REMARKS

In response to the Final Office action dated October 22, 2009, Applicant respectfully requests reconsideration based on the above amendments and the following remarks. Applicant respectfully submits that the claims as presented are in condition for allowance.

FIG. 8

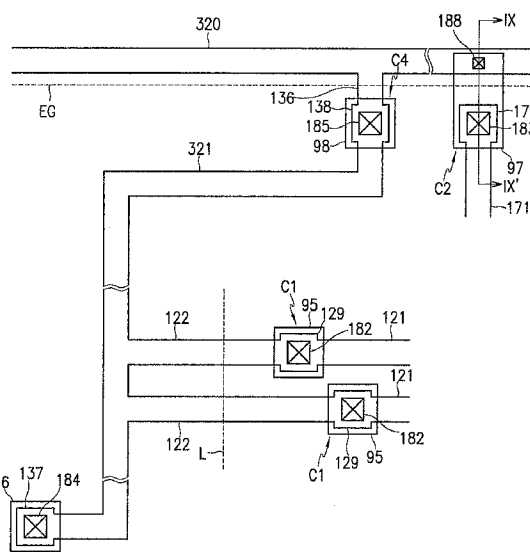
Regarding **Claim 34**, it is alleged in the instant Office action “a driving signal wire (322/321) which transmits driving signals from an outside of the substrate to the gate driver and which comprises a first protrusion portion (no “first protrusion” shown in Figure 6) extended toward the gate pad, wherein the gate pad (95) comprises a second protrusion portion (122) extended toward the driving signal wire” is not shown in the drawings or described in the specification, and that there is no “first protrusion portion adjacent to and insulated from the second protrusion” in Figures 6 and 8. Applicant respectfully disagrees for the reasons set forth below.

Regarding **Claims 39 and 40**, it is alleged in the instant Office action “a first end of each of the plurality of first connecting portions is connected to the first driving signal wire and a second end of each of the plurality of first connecting portions is connected to the gate pad and each of the plurality of first connecting portions is divided into two parts” and “a first end of each of the plurality of second connecting portions connect to the second driving signal wire and a second end of each of the plurality of second connecting portions connects to the gate pad and each of the plurality of second connecting portions is divided into two parts” is respectively not shown in the drawings. Applicant respectfully disagrees for the reasons set forth below.

That is, the driving signal wire (321) connects to the gate pad (129) through the connecting portion (122). The connecting portion (122) is cut along a cutting line (dotted line L), and one portion of the connecting portion (122) remains connected to the driving signal wire (321). Thus, the one portion of the connecting portion (122) remaining connected to the driving signal wire (321) is the “first protrusion” as claimed.

The remaining portion of the connecting portion (122), which is separated from the “first protrusion,” is connected to the gate pad (129), extends toward the driving signal wire (321), and is adjacent to the one portion of the connecting portion (122) (as the “first protrusion”), as claimed. Since the connecting portion (122) is cut along a cutting line (dotted line L) (e.g., into a portion to the left of line L, and a portion to the right of line L), the one (left) portion of the connecting portion (122) (as the “first protrusion”) and the remaining (right) portion of the connecting portion (122) are insulated from each other.

Therefore, Applicant respectfully submits that “a driving signal wire (322/321) which transmits driving signals from an outside of the substrate to the gate driver and which comprises a first protrusion portion (the left portion of the connecting portion (122) remaining connected to the driving signal wire (321) in Figures 6 and 8 and described above) extended toward the gate pad (129), wherein the gate pad (129) comprises a second protrusion portion (the right portion of the connecting portion (122) remaining connected to the gate pad (129) in Figures 6 and 8 and described above) extended toward the driving signal wire (321) and the first protrusion portion is adjacent to and insulated from the second protrusion,” is shown in at least Figures 6 and 8, is described in the specification, and is not new subject matter.

As discussed above with respect to Claim 34, the connecting portion (122) is cut along a cutting line (dotted line L), and a portion of the connecting portion (122) remains connected to the driving signal wire (132) as the “first protrusion” of the claimed invention. The remaining portion of the connecting portion (122) is connected to the gate pad (129).

That is, “a first end of each of the plurality of first connecting portions (top 122) is connected to the first driving signal wire (321) and a second end of each of the plurality of first connecting portions (top 122) is connected to the gate pad (top 129) and each of the plurality of first connecting portions (top 122) is divided into two parts (one to the left of line L and one to the right of line L). ”

Similarly, “a first end of each of the plurality of second connecting portions (bottom 122) connect to the second driving signal wire (322) and a second end of each of the plurality of second connecting portions (bottom 122) connects to the gate pad (bottom 129) and each of the plurality of second connecting portions is divided into two parts (one to the left of line L and one to the right of line L).”

Therefore, Applicant respectfully submits that “each of the plurality of first connecting portions is divided into two parts” and “each of the plurality of second connecting portions is divided into two parts” of Claims 39 and 40 are shown in at least Figures 6 and 8, and are described in the specification.

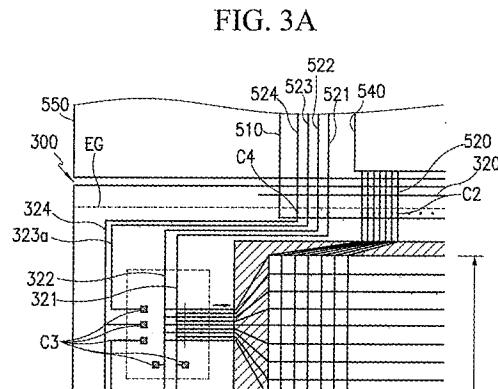
Regarding **Claim 36**, it is alleged in the instant Office action “a flexible printed circuit connected to the substrate and comprising a first driving pad” is not shown in the drawings or described in the specification.

Regarding **Claim 37**, it is alleged in the instant Office action “wherein the gate driver connected the driving signal wire” is not shown in the drawings or described in the specification.

Regarding **Claim 42**, it is alleged in the instant Office action “a flexible printed circuit connected to the substrate and comprising a first driving pad and a second driving pad” is not shown in the drawings.

In response, Claim 36 is hereinabove amended to include “a test pad and a first driving pad disposed on the substrate, and a flexible printed circuit connected to the substrate through the first driving pad.”

Referring to Figure 3A (from Corrected Drawings filed April 23, 2007, reproduced below), C4 indicates the “first driving pad” of the claimed invention. A non-limiting embodiment is described in the specification as follows:

Therefore, Applicant respectfully submits that “a test pad and a first driving pad disposed on the substrate, and a flexible printed circuit connected to the substrate through the first driving pad” of amended Claim 36 is shown in at least Figure 3A, and is described in the specification.

In response, Claim 37 is hereinabove amended to include “further comprising a second driving pad disposed on the substrate, wherein the gate driver connects to the driving signal wire through the second driving pad.”

Referring to Figure 3A (from Corrected Drawings filed April 23, 2007, reproduced above), C3 indicates the “second driving pad” of the claimed invention. A non-limiting embodiment is described in the specification as follows:

Therefore, Applicant respectfully submits that “further comprising a second driving pad disposed on the substrate, wherein the gate driver connects to the driving signal wire through the second driving pad” of amended Claim 37 is shown in at least Figure 3A, and is described in the specification.

In response, Claim 42 is hereinabove amended to include “a first driving pad and a second driving pad disposed on the substrate, and a flexible printed circuit connected to the substrate through the first driving pad and the second driving pad.”

As discussed above with respect to Claims 36 and 37, C4 indicates the “first driving pad” and C3 indicates the “second driving pad” of the claimed invention.

For all the reasons discussed above, Applicant respectfully submits that “a first driving pad and a second driving pad disposed on the substrate, and a flexible printed circuit connected to the substrate through the first driving pad and the second driving pad” of amended Claim 42 is shown in at least Figure 3A, and described in the specification.
